Item H-3

PUBLIC HEARING: Consider an ordinance approving a Specific Use Permit (SUP) for Lidl, 35,962 square-foot, single-story grocery store, located on a 4.95-acre tract, on the north side of Keller Parkway (FM 1709) approximately 1,200 feet west of Keller Smithfield Road, being tract 2E and 3 in the Pamela Allen Survey, Abstract No. 28, at 1221 and 1301 Keller Parkway, and zoned TC (Town Center). Greenway-Keller, L.P., owner. Kimley-Horn and associates, applicant/engineer. (SUP-17-0017)

Item H-4

Consider a resolution approving a Site Plan with variances for Lidl, 35,962 square-foot, single-story grocery store, located on a 4.95-acre tract, on the north side of Keller Parkway (FM 1709) approximately 1,200 feet west of Keller Smithfield Road, being tract 2E and 3 in the Pamela Allen Survey, Abstract No. 28, at 1221 and 1301 Keller Parkway, and zoned TC (Town Center). Greenway-Keller, L.P., owner. Kimley-Horn and associates, applicant/engineer. (SP-17-0016 and UDC-17-0016)

Item H-3 (SUP) Exhibits (Updated)

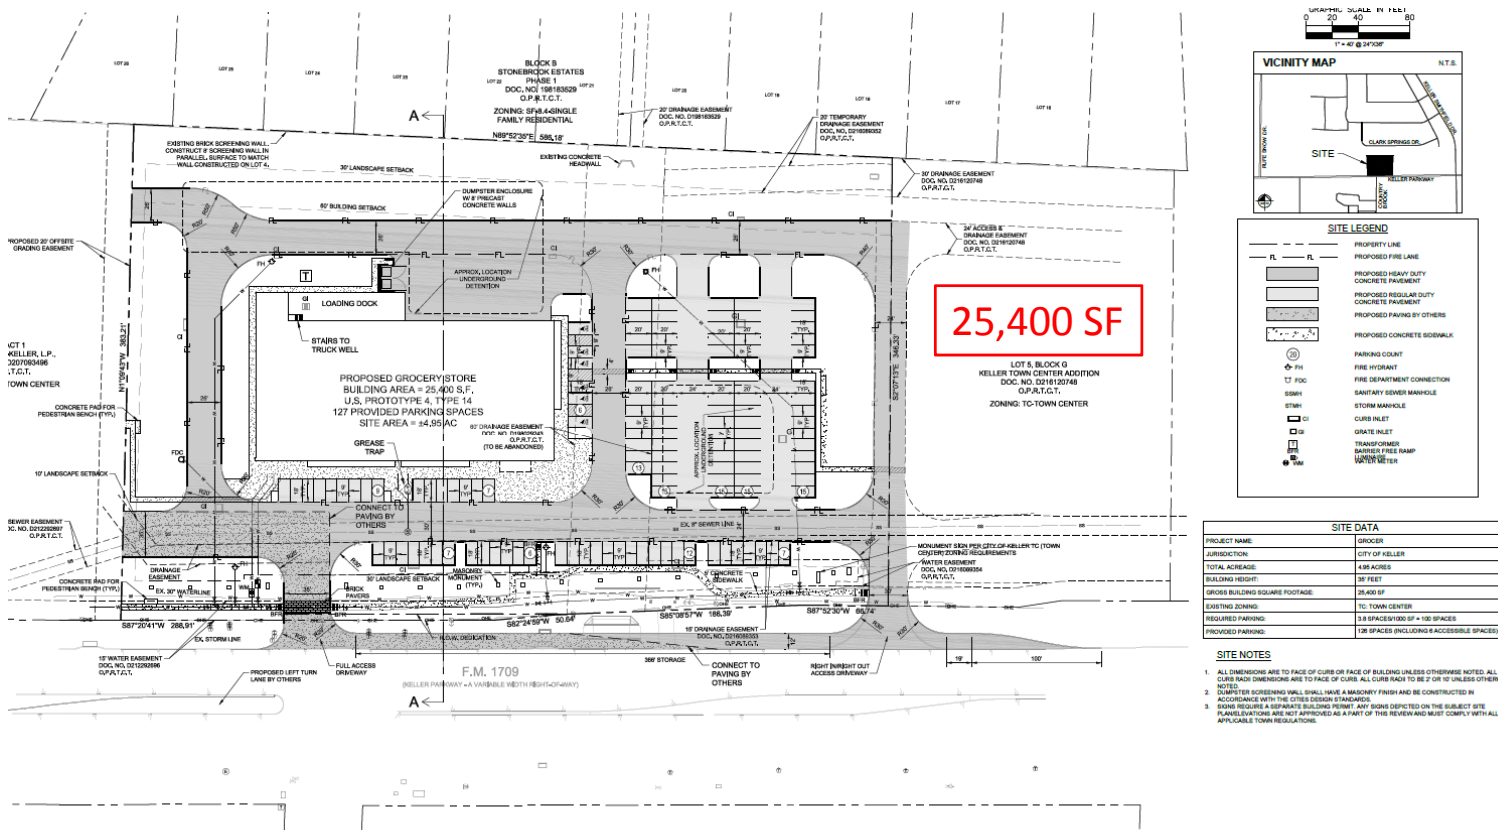
- 3rd Row of parking removed.
- Building square footage reduced (from 35,640 to 25,600)
- Service Area and Dumpster Enclosure moved to rear of the building.

Item H-4 (Site Plan) Exhibits (Updated)

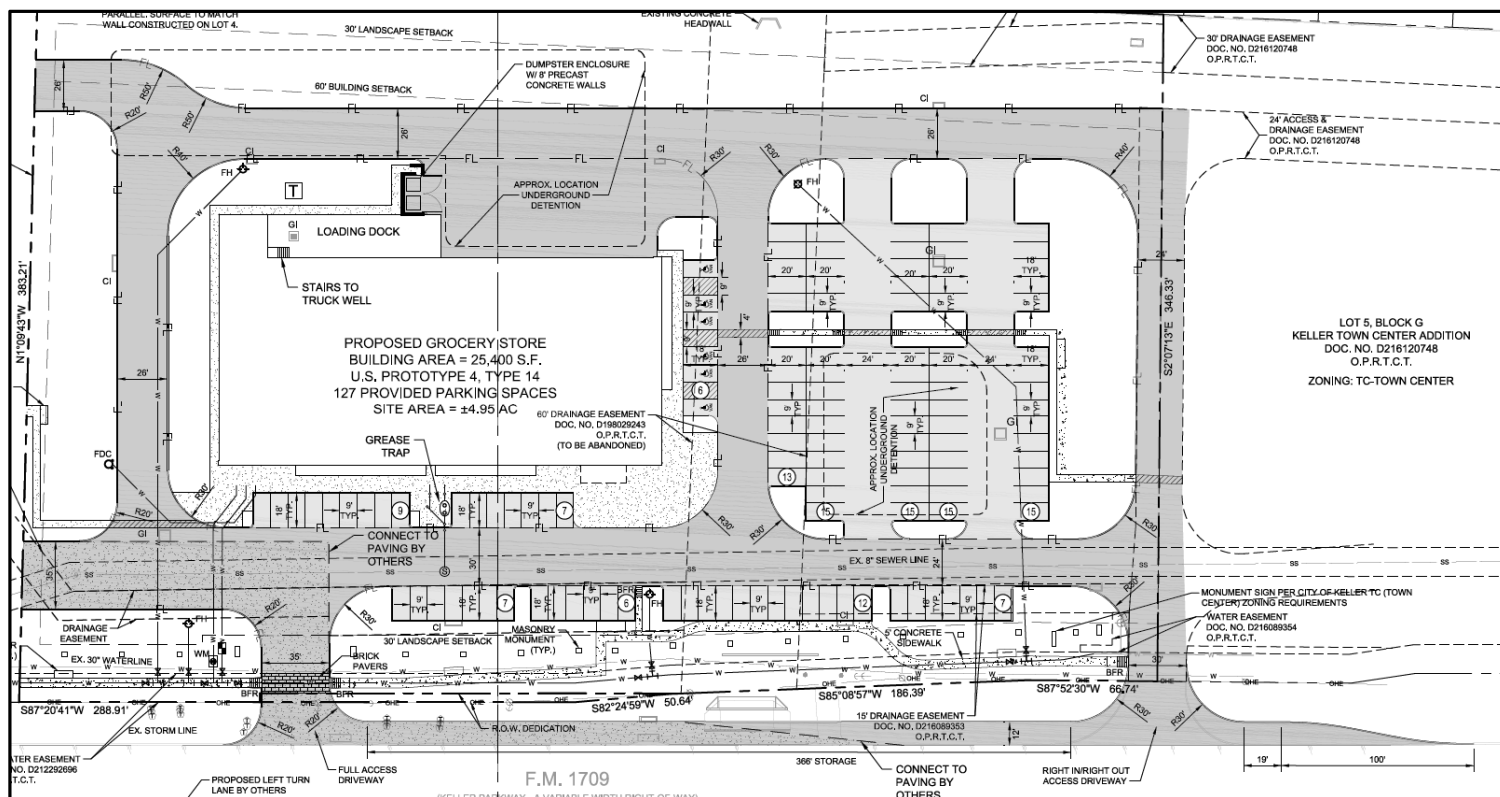
- Layout has been updated to move the Loading Area/Dumpster Enclosure to the rear of the property.
- Square footage has changed from 35,962 SF to 25,400 SF.
- SUP approval required for site plan to be considered.

Item E-1 (Site Plan) Exhibits

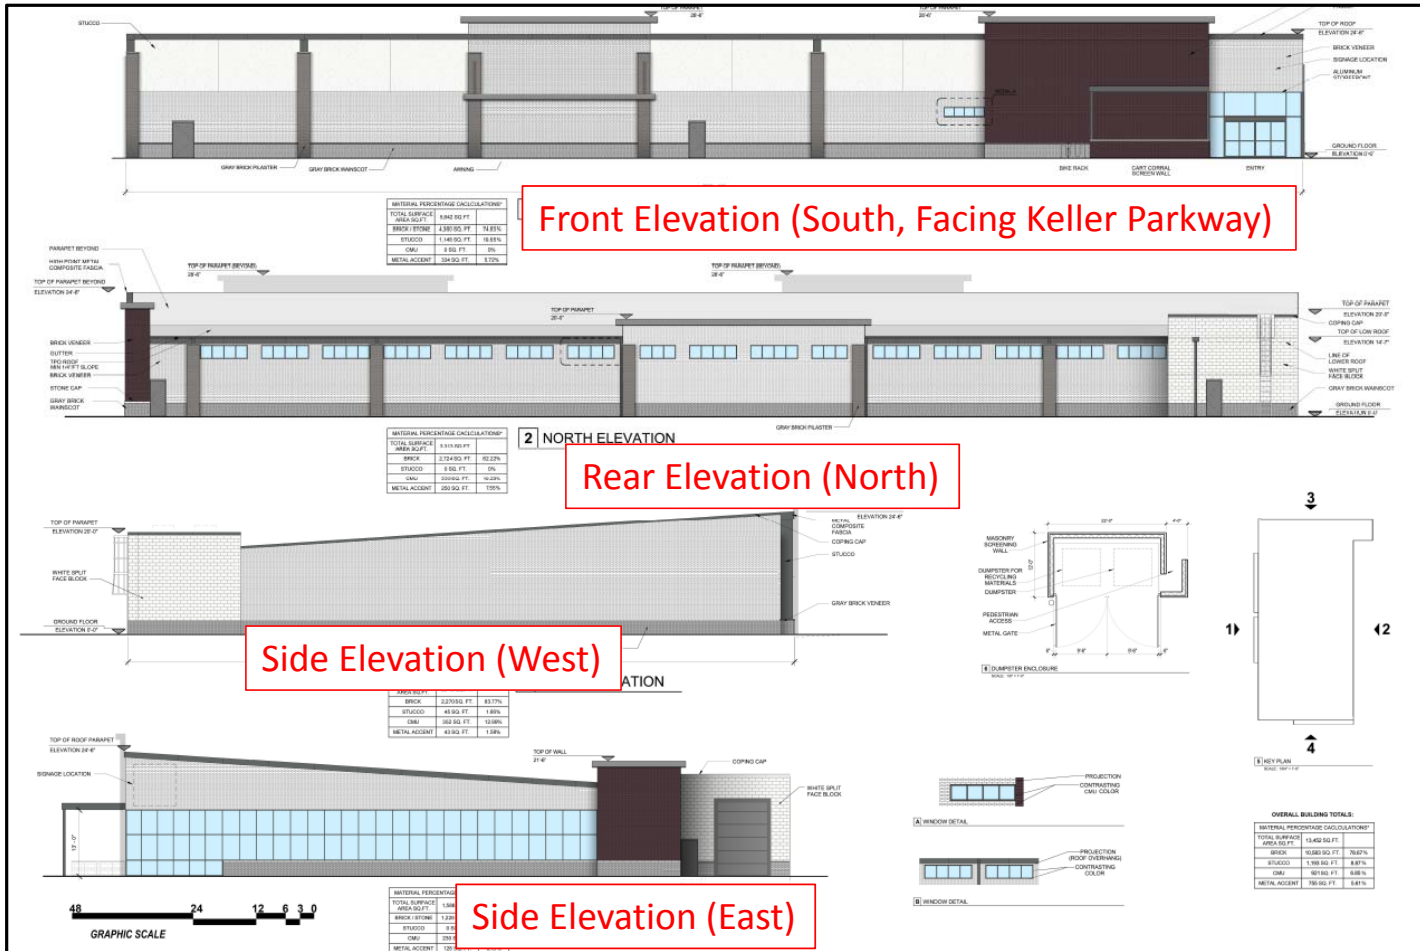
1. A variance is requested to waive the building articulation on the west building elevation.
2. A variance is requested to Section 8.03 (P.4.c.7) for limited window treatment on the south elevation as shown in "Exhibit A."
3. A variance is requested to allow metal faced accent materials on the north and west elevations, as shown in Exhibit A.
4. A variance to Section 8.03 (P.4.c.8) is requested to allow a curved TPO roof.

Should the SUP be approved, staff **does not** support the following variances:

1. A variance is requested to waive the building articulation on the west building elevation.
2. A variance is requested to Section 8.03 (P.4.c.7) for limited window treatment on the south elevation as shown in “Exhibit A.”

Based on site conditions, architecture and past developments in Town Center, staff **supports** the following variances:

3. A variance is requested to allow metal faced accent materials on the north and west elevations, as shown in Exhibit A.
4. A variance to Section 8.03 (P.4.c.8) is requested to allow a curved TPO roof.
5. A variance is requested to allow a break in the landscaping along Keller Parkway to allow for the drainage facility.

Item E-2 (Site Plan)

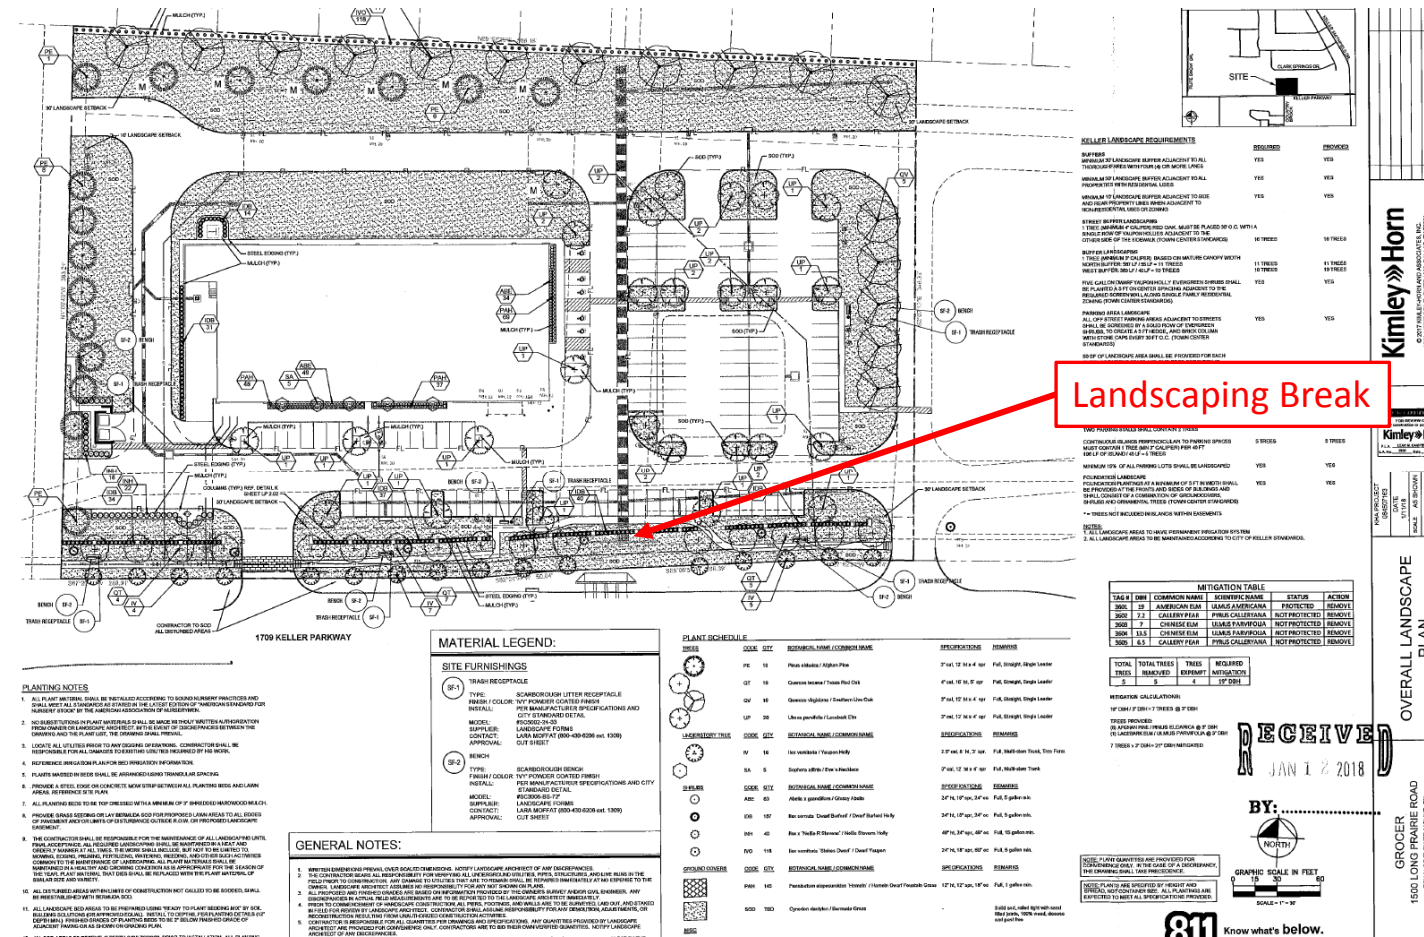
- A variance is requested to allow a break in the landscaping along Keller Parkway to allow for the drainage facility.
